ADDENDUM NO. 1

**HANOVER COMMUNITY SCHOOL CORPORATION - NEW RESOURCE
CENTER AND RELATED WORK
Cedar Lake, IN 46303**

This Addendum consists of page ADD 1-1 and attached Addendum No. 1 from Gibraltar Design dated May 27, 2021 and consisting of 5 pages and 48 drawings.

Z:\cad\projects\2020 - 2028\2021 Projects\2104 Gibraltar Design Hanover\A-502 ENLARGED PLAN DETAILS.dwg, 5/27/2021 1:41:05 PM, jflitzgerald

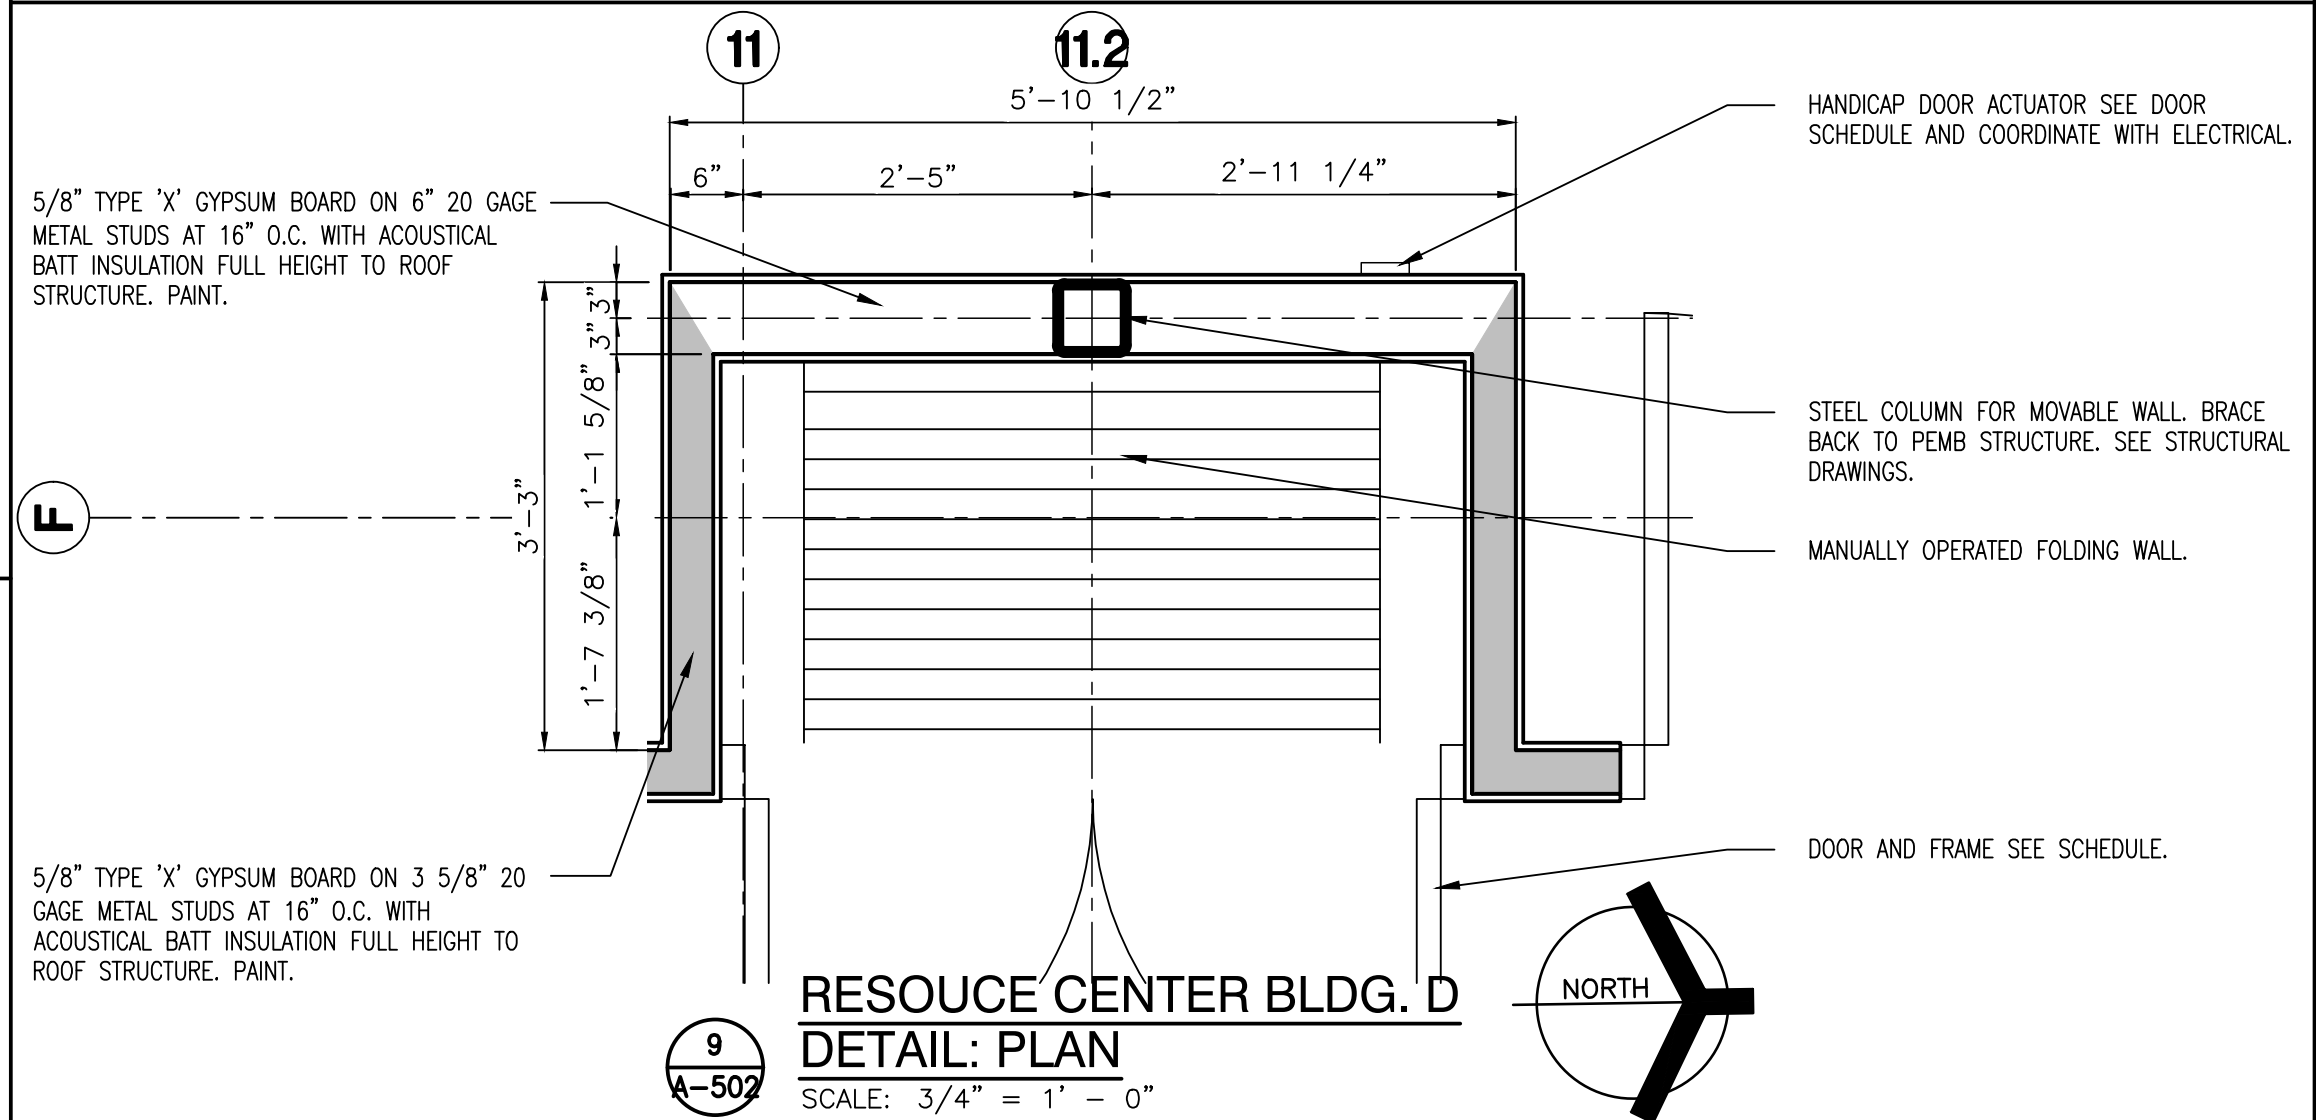
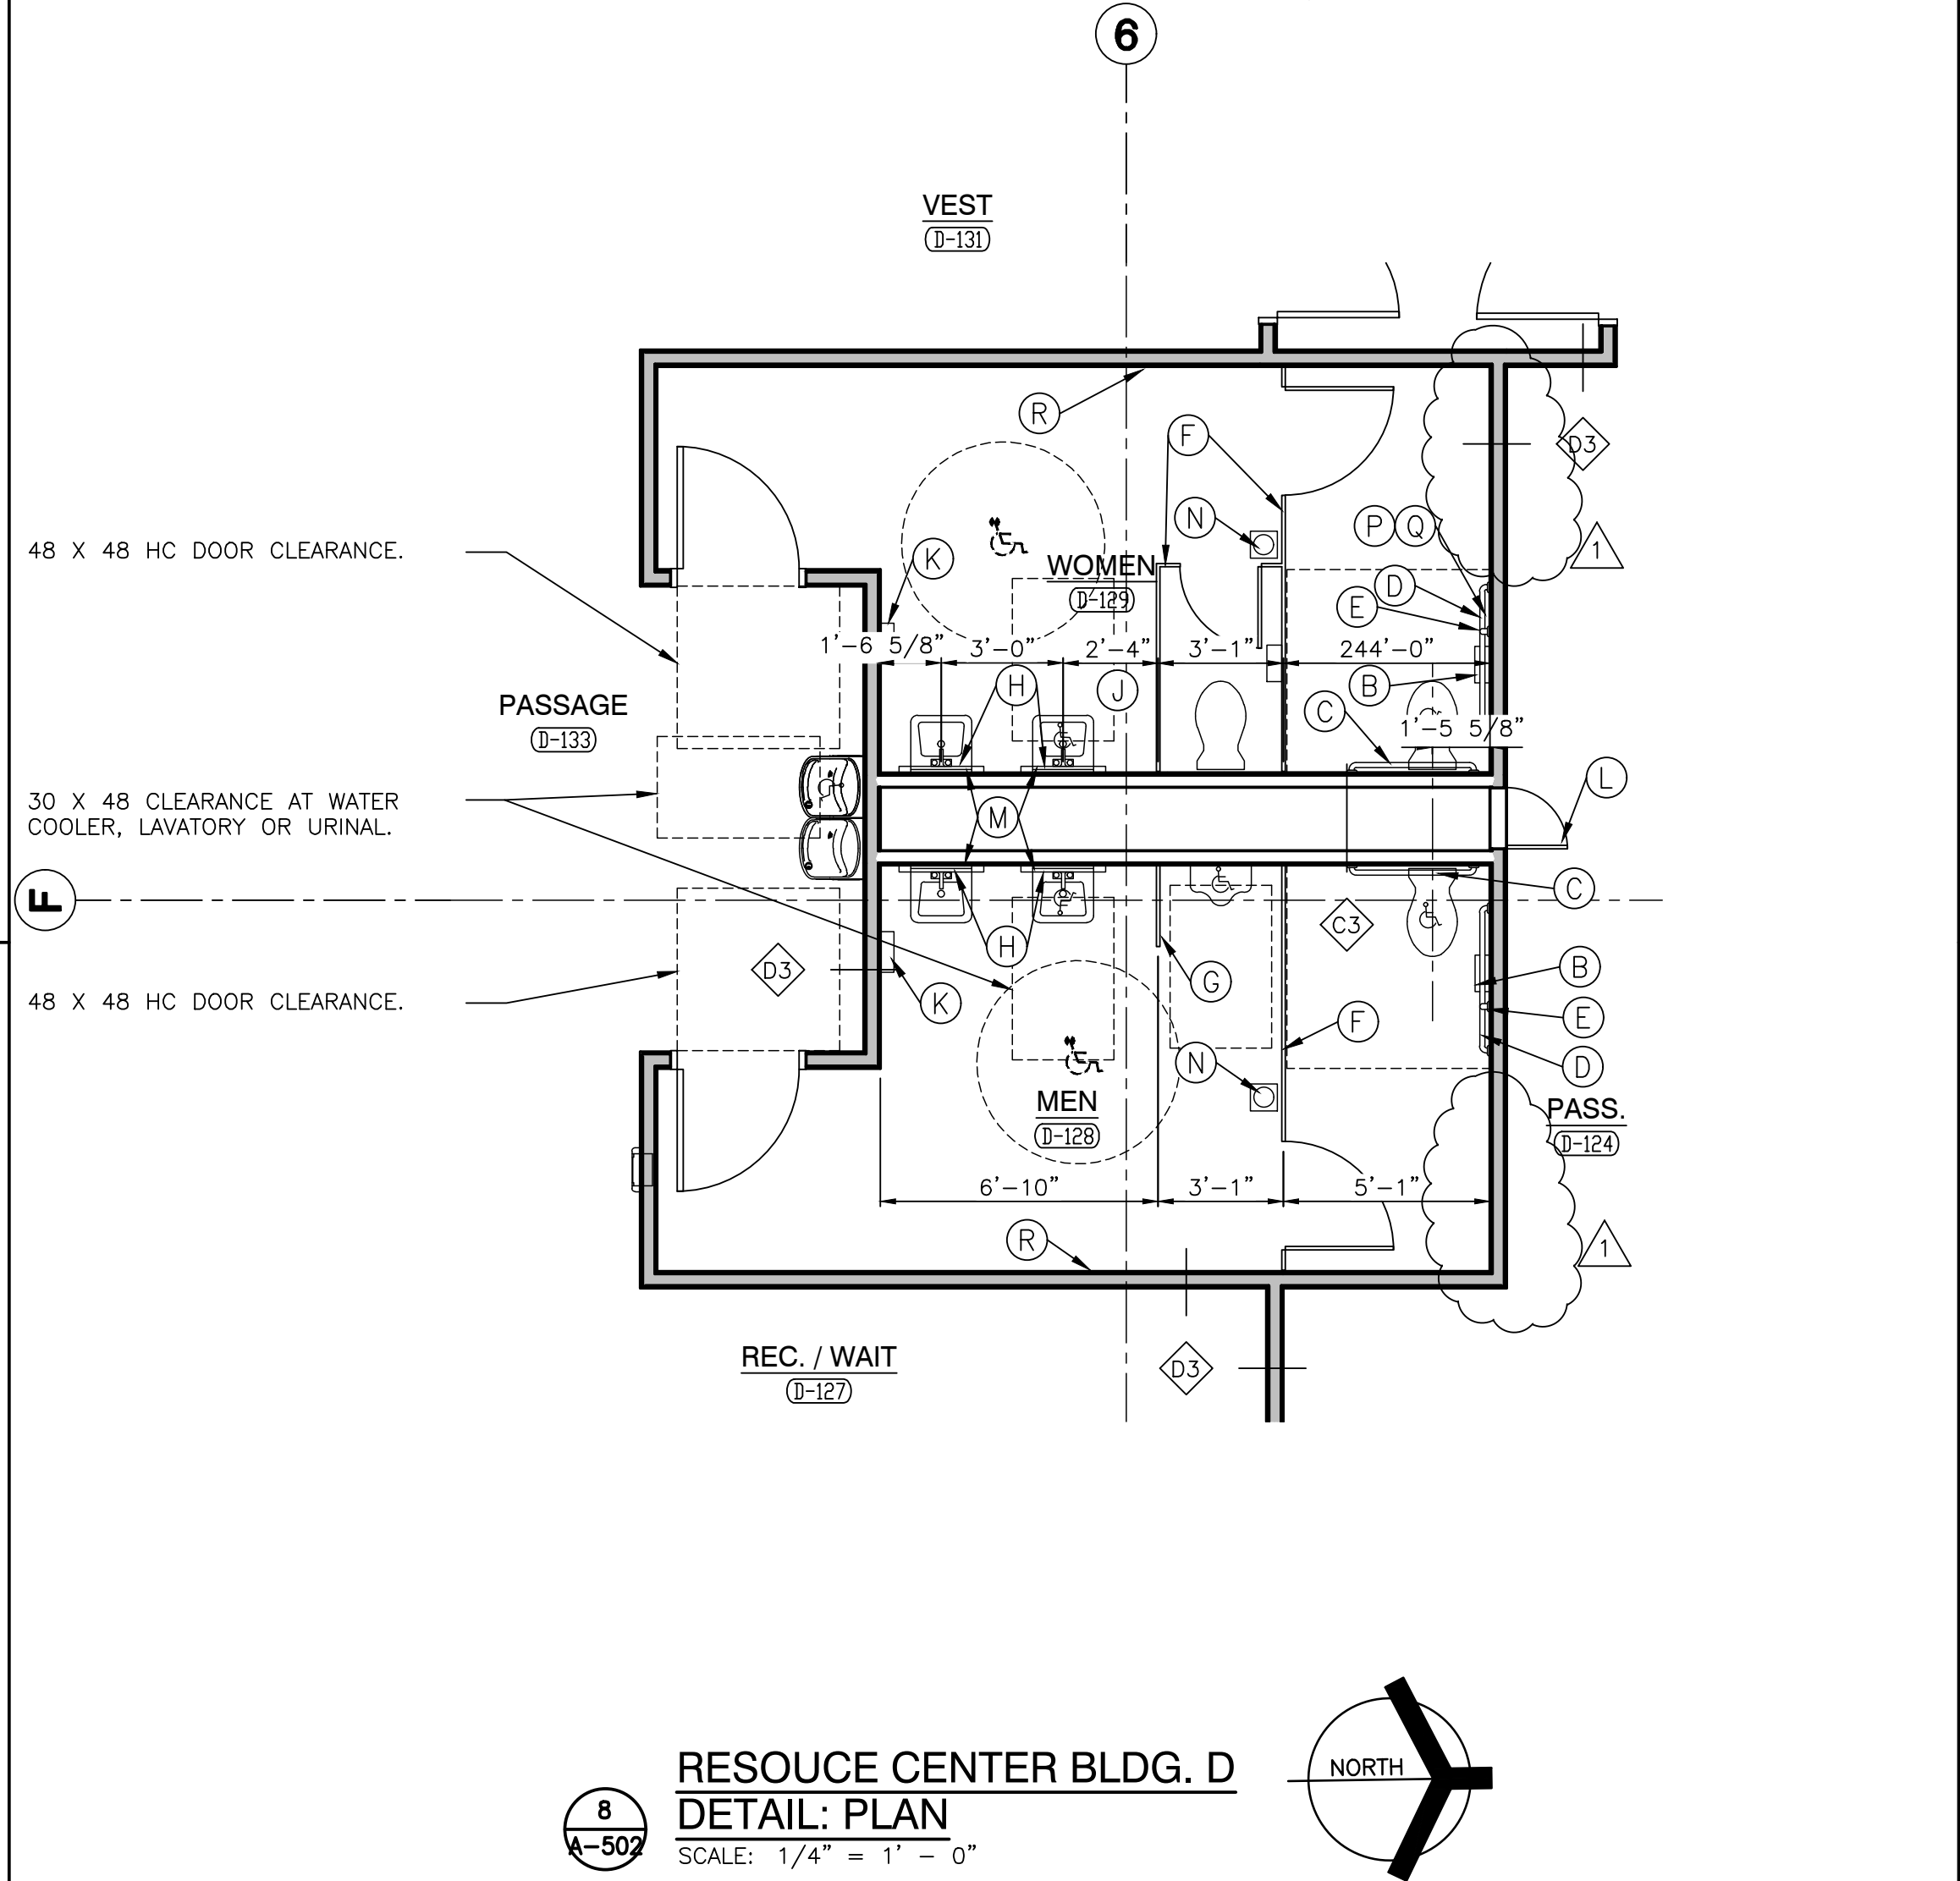
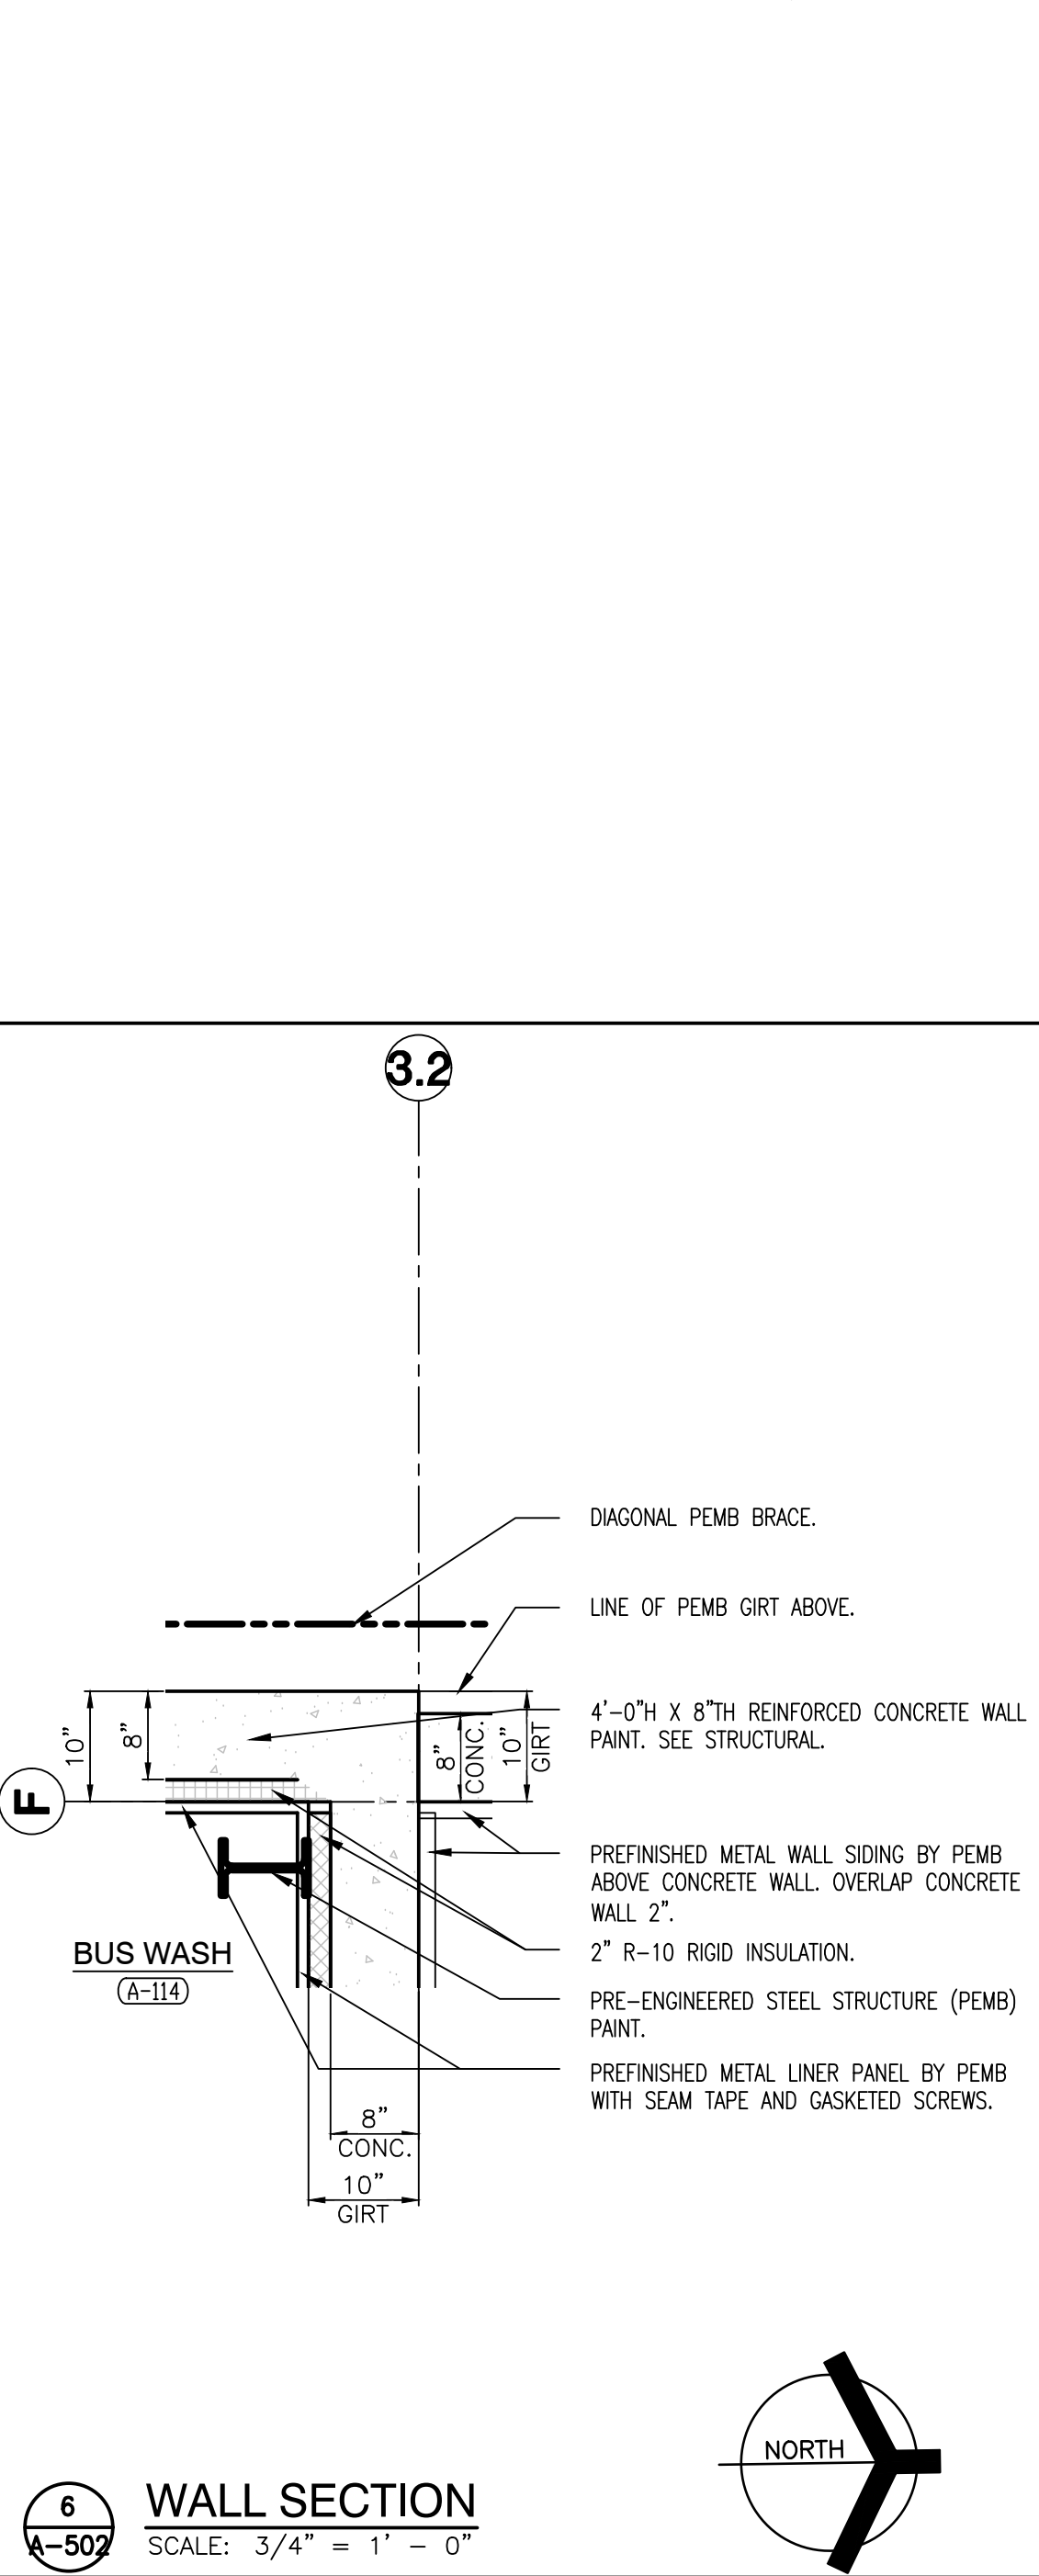
17. Sheet A-502

- A. Refer to Full Size Drawing Sheet included in this Addendum for the following revisions:
 - 1. Delete Baby Changing Table from MEN D-128 and WOMEN D-129.
